Meeting Minutes

**Engineering/Minerals
Tonto National Forest
Phoenix, AZ**

Re: Resolution Groundwater Working Group Meeting 9/12/2018

Negative Drawdown

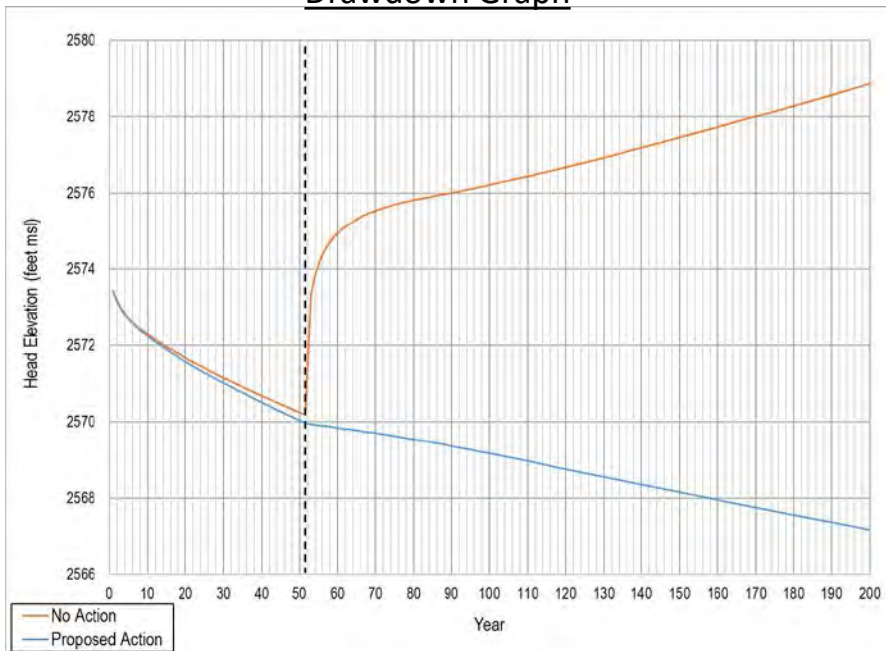
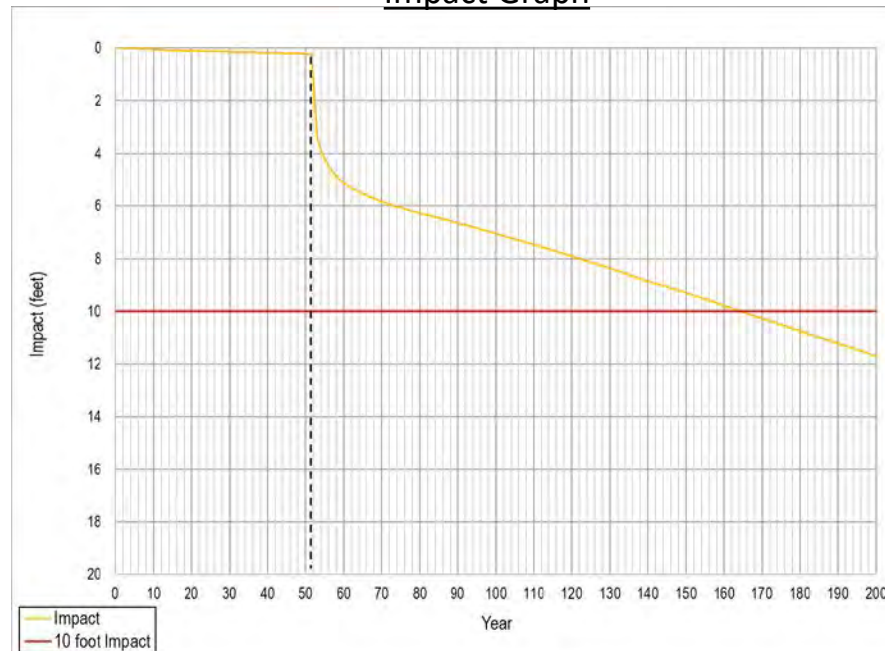
- Modeling is a snapshot of 2016 – includes 7 years of current pumping and effects of pumping since 1910s

- This is a physical reality, not just a mathematical artifact if water tables rebound. See table 2 of 8/6 report

- A question arose as to why there was seemingly higher impact than expected if we were to look at drawdown from initial head values.
- This is due to the dual model approach, where one can evaluate a no-action case where water recovers to a value greater than initially measured.
- This can be clearly seen in the hydrograph for QC17.39 below. The no-action case predicts that heads will rise higher than their values today (potentially restoring flow to Queen Creek) but the proposed action head remains lowered.
- This evaluates a “greater impact” (proposed action minus no-action) than what would simply predicted if a no-action case was not run.

Memo Impact Discrepancy

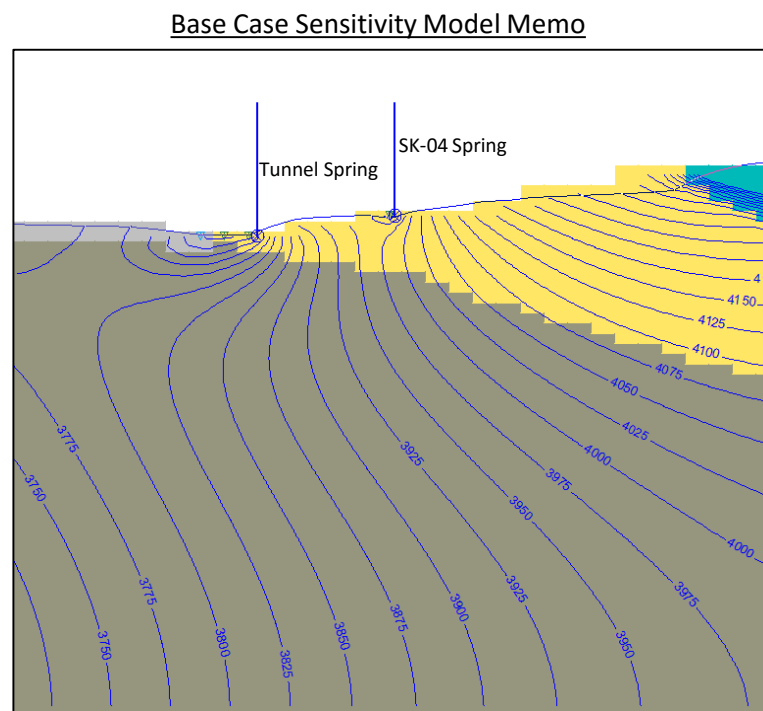
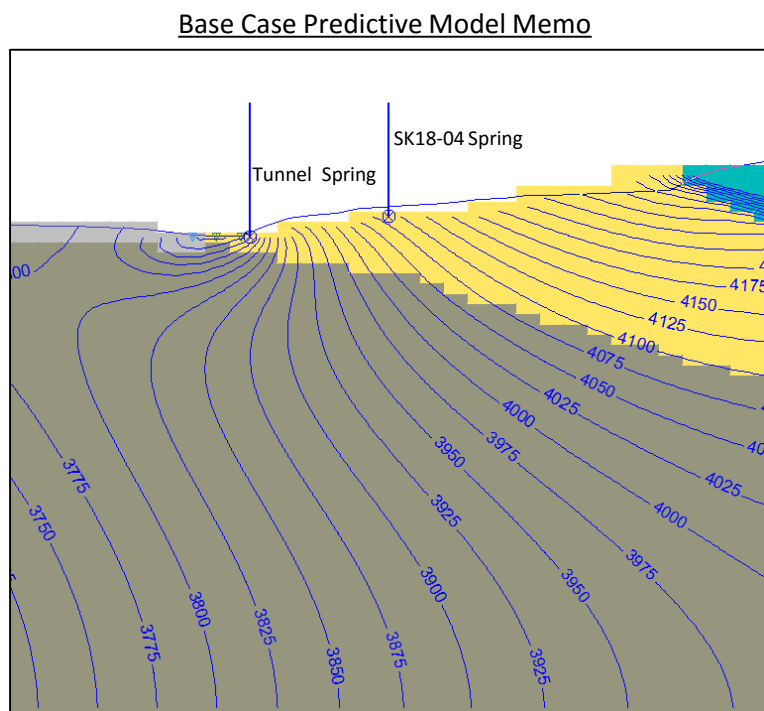
- Sensitivity results were correct (8/31), (8/6) draft predictive modeling did not have GDEs listed as springs. The 8/6 report will be reissued with updated GDEs as springs.
- Location with most change was SK-04. Others with changes included SK02, SK03, and Bitter Springs
- GDE list is now final
- “Final Report”: WSP will reissue the October 2017 report. That will be the final report in addition to the predictive and sensitivity memos. Expect to provide end of September or early October.

- A question arose as to why there was a discrepancy in predicted impacts between the base case predictive memo and the sensitivity memo. This is seen in the area near the Bitter Spring and SK series GDEs.
- The results in the sensitivity memo are correct and the base case memo is not.
- This is due to not having a finalized list of GDEs at the time the first memo was produced and Drain boundary conditions not being applied at these points.
- For the sensitivity memo we did include them and the head was lowered, as is shown below in cross-section view. This changes the results slightly (only in this area) and hence impacts are different.
